QUARANTINE NOTICE

Reference number:	QN-18-0054	Issued: 27 June, 2017
Subject:	Instrument Panel (IP) Ground Plate Mounting	
Model(s):	DB11	
VIN Range:	Refer to the separately published list of affected Vehicle Identification Numbers (VINs)	
Applicable to:	All Dealers	
Distribute to:	After Sales Manager Service Manager Sales Manager	Warranty Staff Technician(s) Parts Staff

Reason for this Quarantine Notice

Figure 1

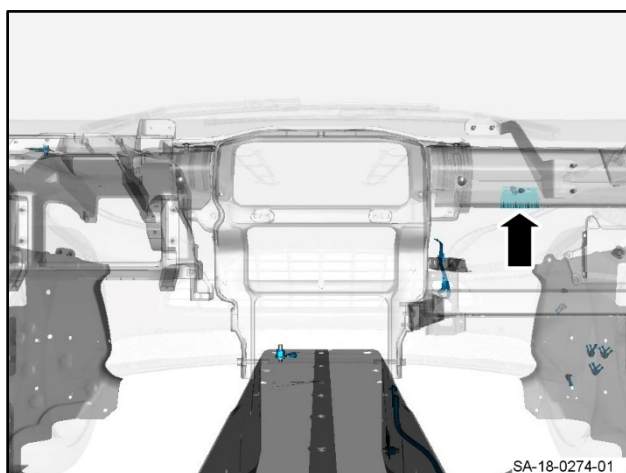
A ground plate mounted on the Instrument Panel (IP) cross car beam can possibly be attached incorrectly on some early DB11 vehicles. Do the procedure that follows to make sure that the ground plate is attached correctly on all applicable vehicles – refer to the separately published list of VINs.

The ground plate is attached to the front surface of the cross car beam. Figure 1 shows the location of the ground plate on LHD vehicles.

Figure 4

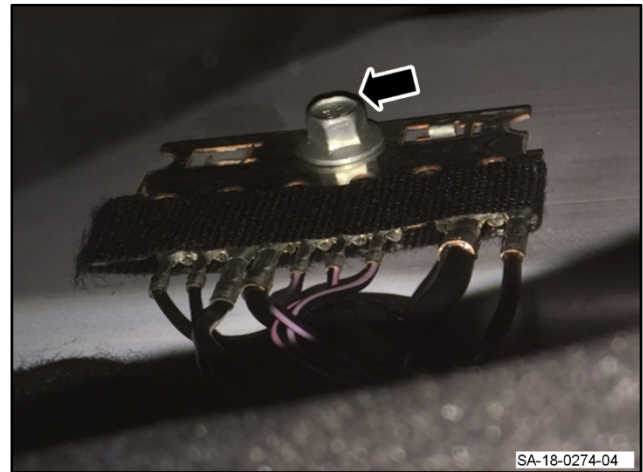
4. Remove and discard the M6 x 10 hexagon-headed flange bolt that attaches the ground plate (refer to Figure 4).

7. Install a new M6 x 25 setscrew to attach the ground plate to the cross car beam. Torque to 9 Nm.
8. Put the right-side lower foot-duct back into the correct position on the cross car beam. Install and tighten the screw that attaches the duct to the beam.
9. Install the passenger's side bottom instrument panel (IP) assembly (Refer to Workshop Manual procedure 01.12.AG).
10. Install the right side trim panel for the centre console (Refer to Workshop Manual procedure 01.12.DX).

Figure 5

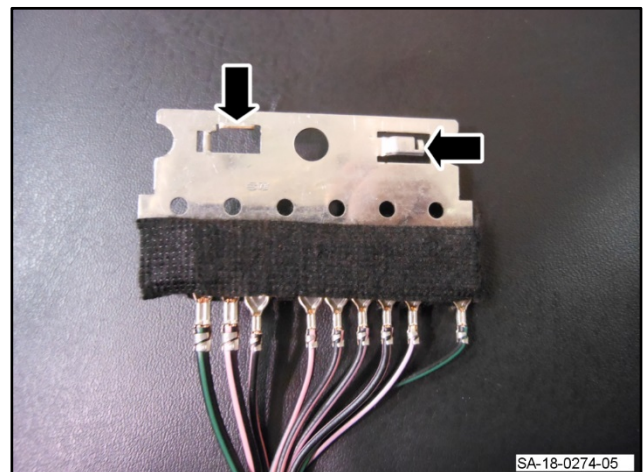
5. The ground plate has raised tabs on one surface (refer to Figure 5).

6. Make sure that you install the ground plate so that the raised tabs point away from the cross car beam (refer to Figure 6). To make sure that a good ground path is made, the flat surface of the ground plate must touch the cross car beam.
